Docket No. 50-353

Subject: Limerick Generating Station, Unit 2
Technical Specifications Change Request No. 00-02-2
Changes to Reactor Pressure Vessel Pressure-Temperature Limits
Supplemental Information

**TECHNICAL SPECIFICATIONS CHANGE REQUEST
NO. 00-02-2**

MINIMUM REACTOR VESSEL METAL TEMPERATURE VS. REACTOR VESSEL PRESSURE
FIGURE 3.4.6.1-1

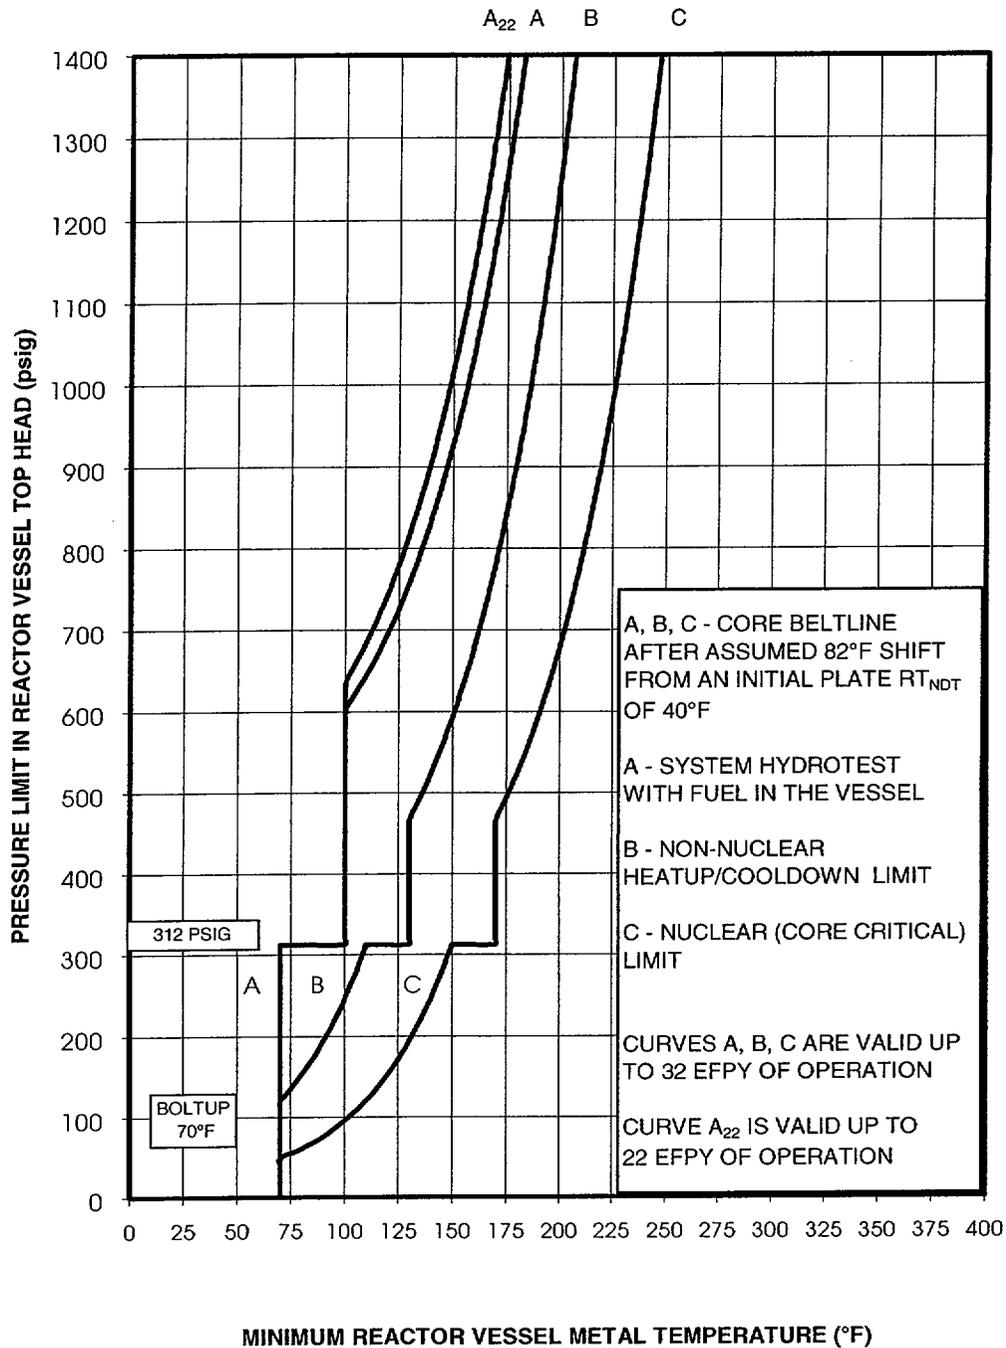
The purpose of this letter is to request interim approval of the 32 EFPY P-T limits until the end of the next operating cycle (i.e., Cycle 7) for LGS Unit 2, currently scheduled for April 2003. In a teleconference between members of the NRC and PECO Energy on December 6, 2000, the NRC indicated that the neutron fluence used to develop the revised P-T limits did not reflect the guidance contained in Draft Regulatory Guide DG-1053, "Calculational and Dosimetry Methods for Determining Pressure Vessel Neutron Fluence," dated September, 1999, and therefore, the NRC could not support approval of

the new P-T limits out to 32 EFPY. During subsequent follow-up teleconferences with the NRC, PECO Energy requested interim approval of the P-T limits. Attachment 1 provides the revised "camera-ready" TS page for LGS Unit 2 TS Figure 3.4.6.1-1, "Minimum Reactor Vessel Metal Temperature vs. Reactor Vessel Pressure" which reflects the interim approval request.

Note: In accordance with NRC Safety Evaluation supporting Amendment No. _____, this Figure is valid through Cycle 7 Operation, currently scheduled to end in April 2003.
